PRELIMINARY DRAINAGE REPORT
FOR
VILLAGES AT STERLING RANCH

PCD Project No.
PUDSP-226

FINAL DRAINAGE REPORT FOR
VILLAGES AT STERLING RANCH

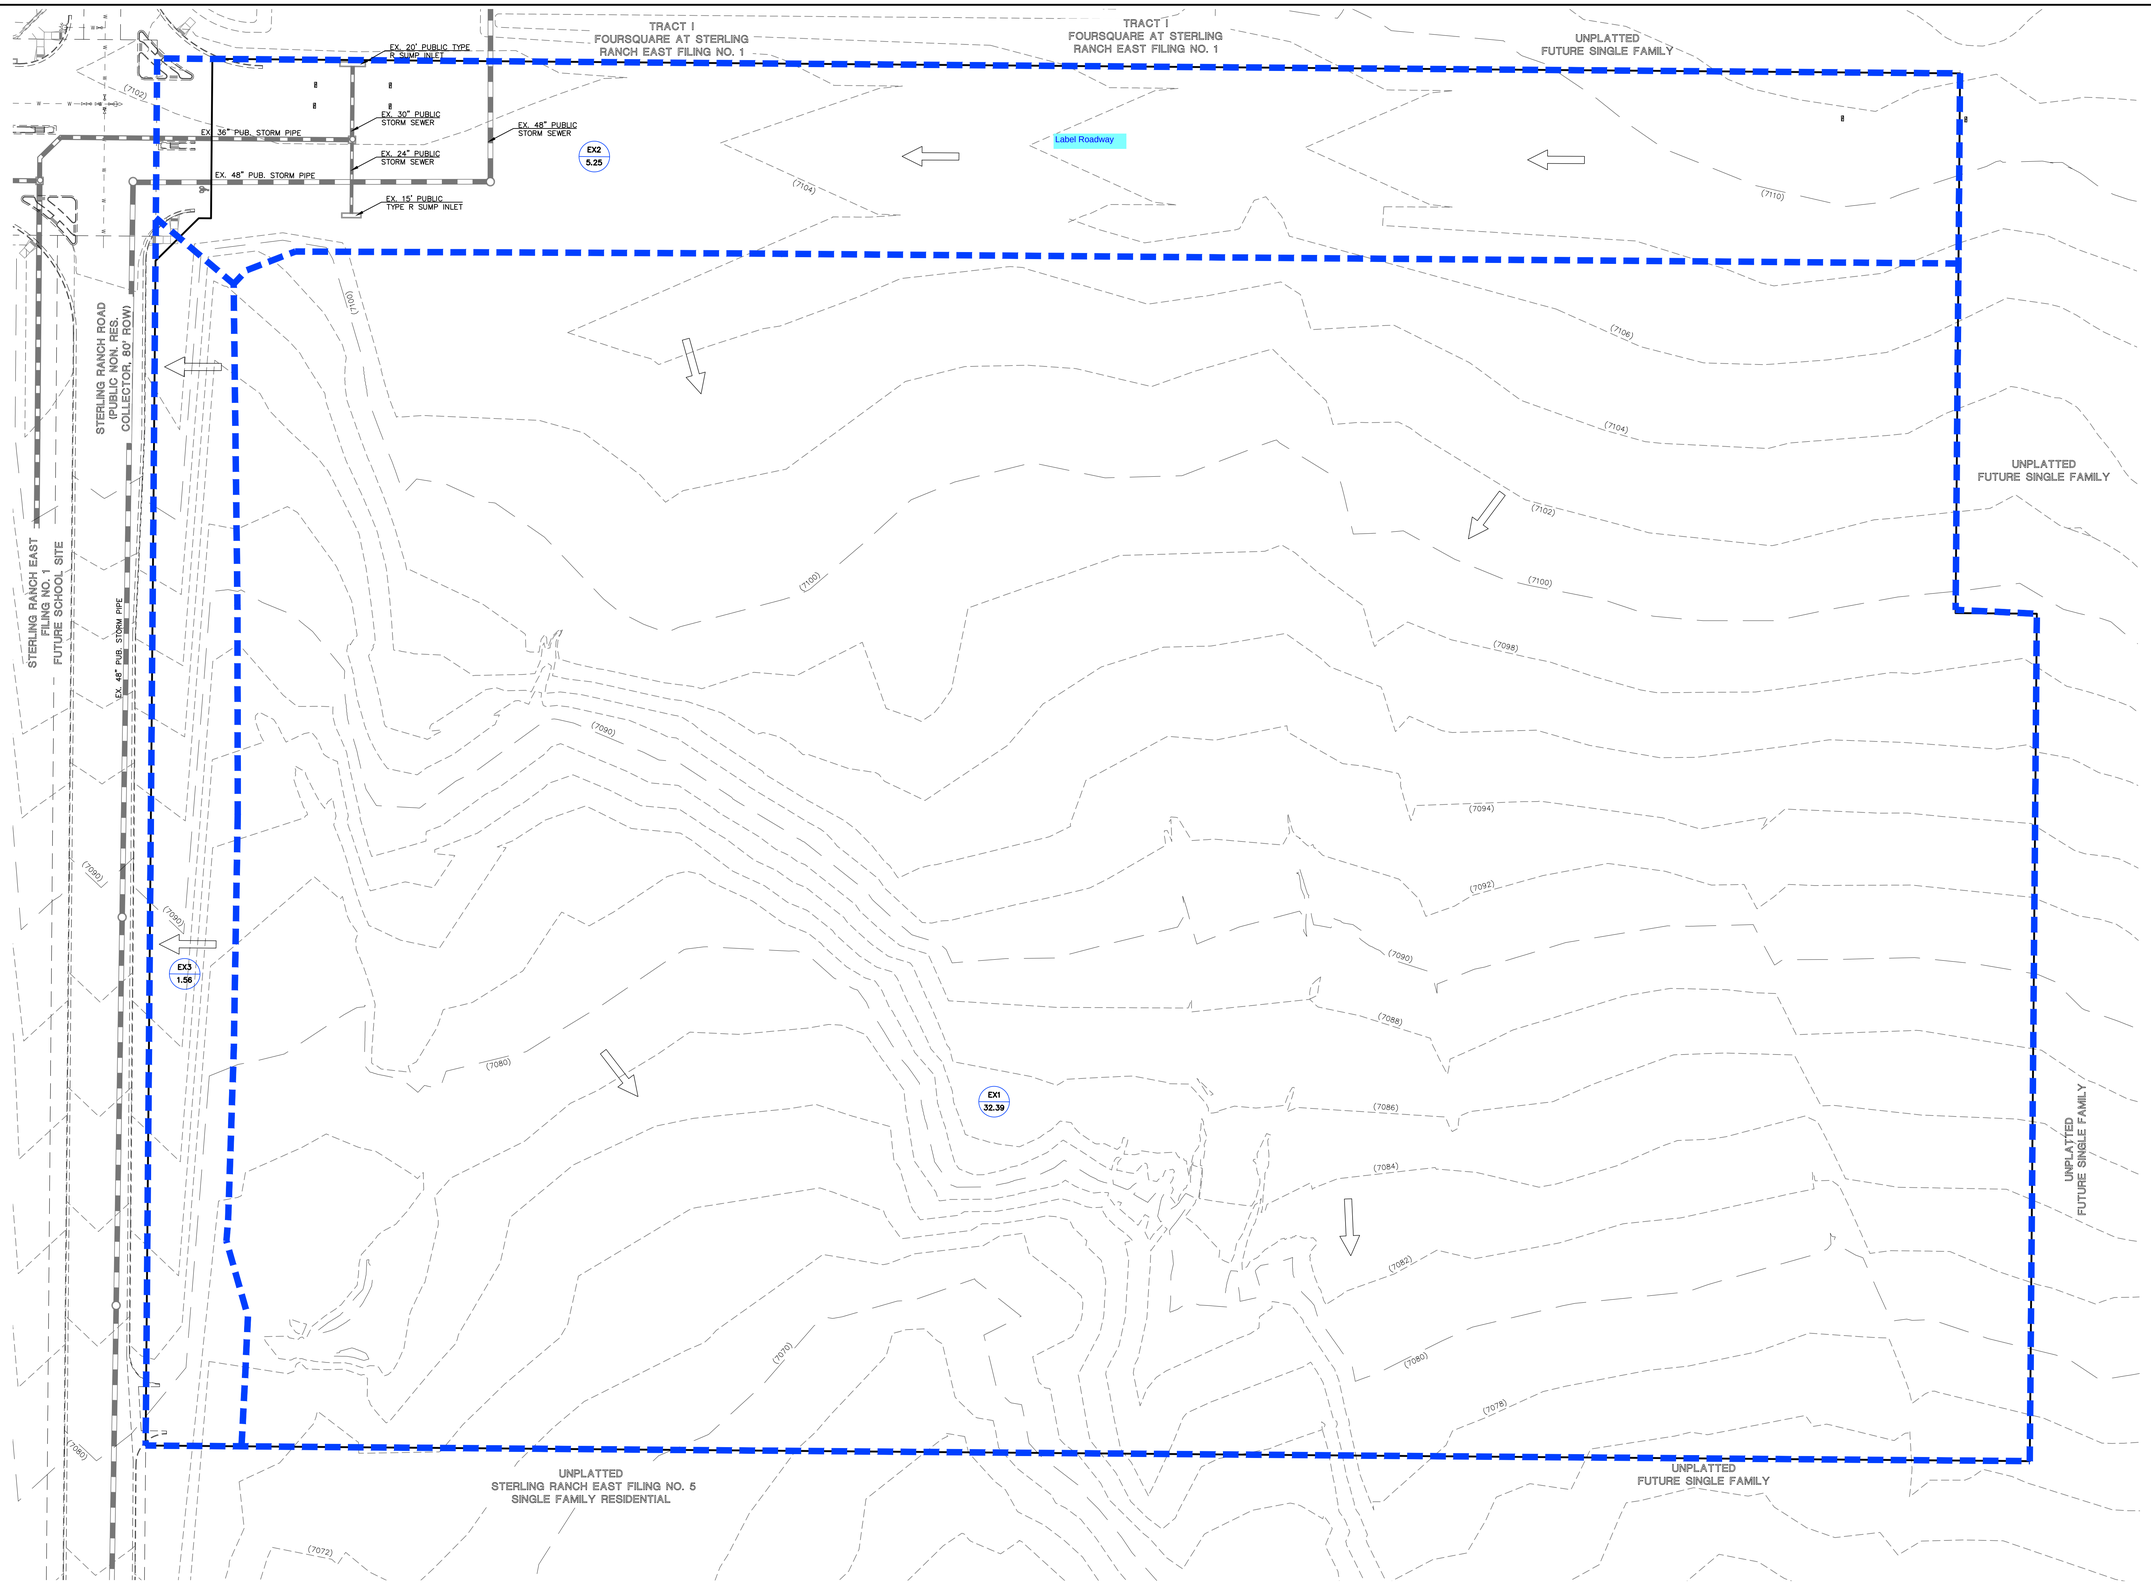
Provide hydrologic calculations
for 3 existing drainage basins

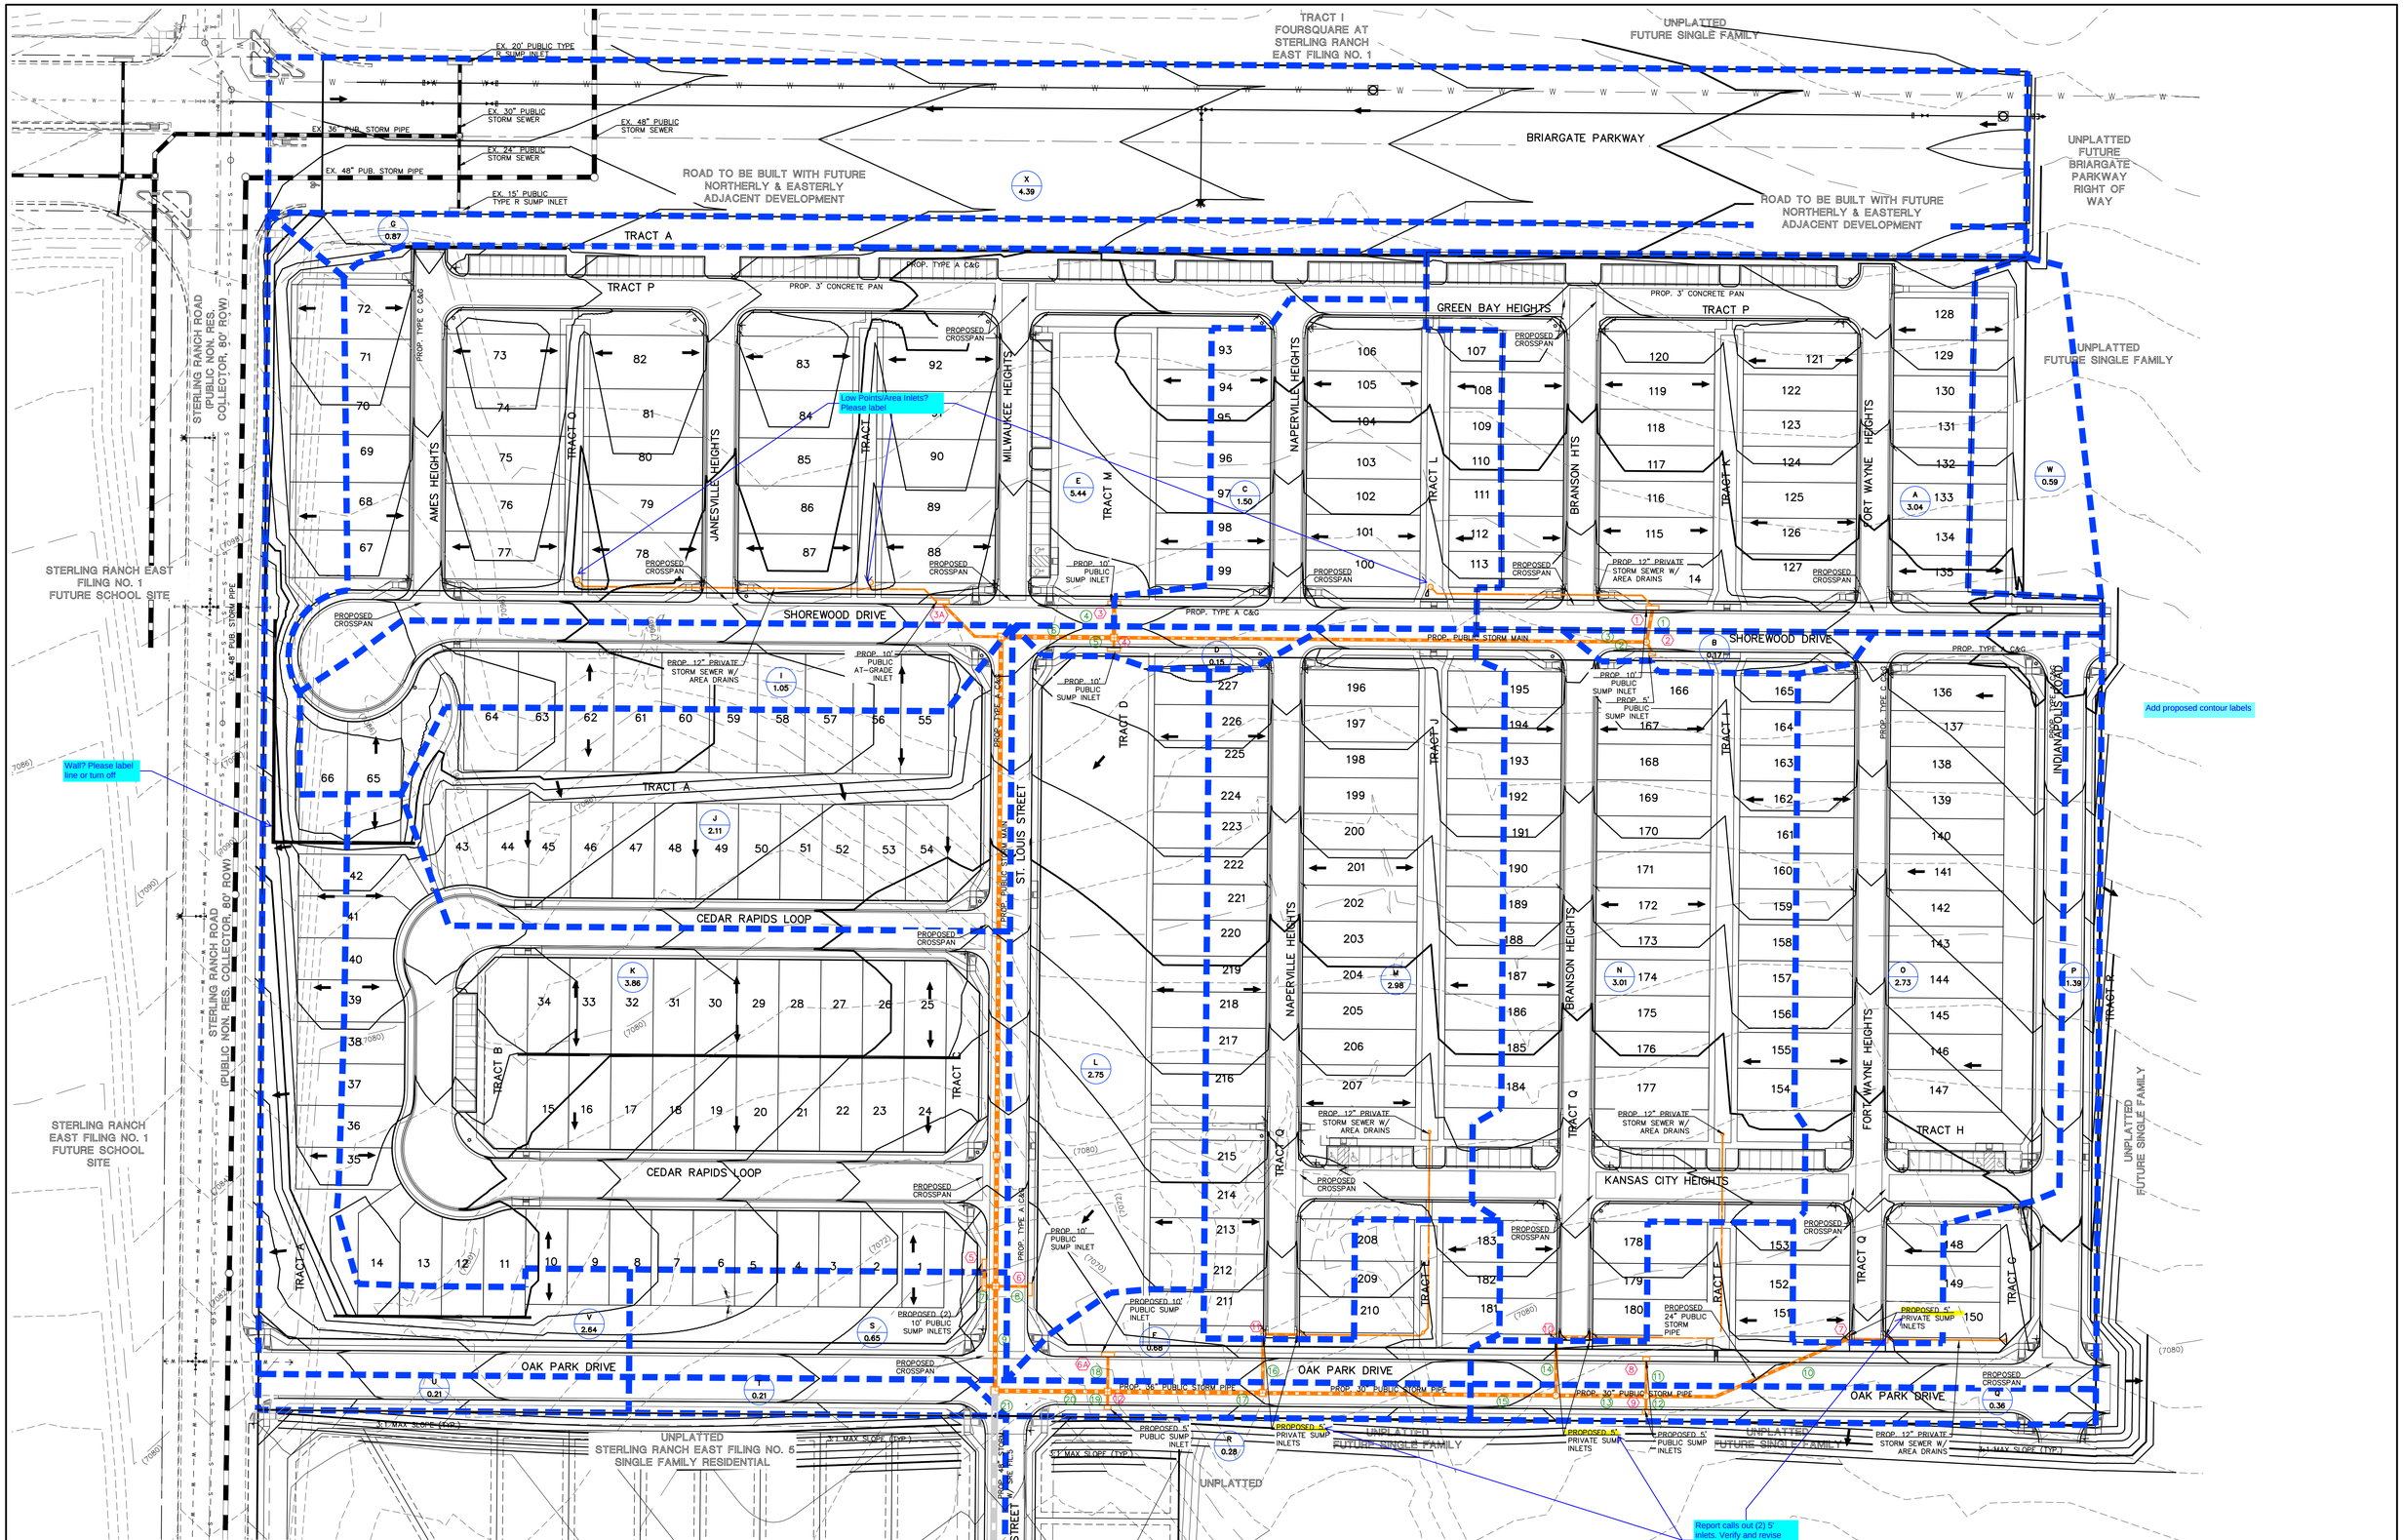
Basin D?

Would Basin S be more likely to flow straight through the cross pan to DP 6A instead of turning and going to DP6?
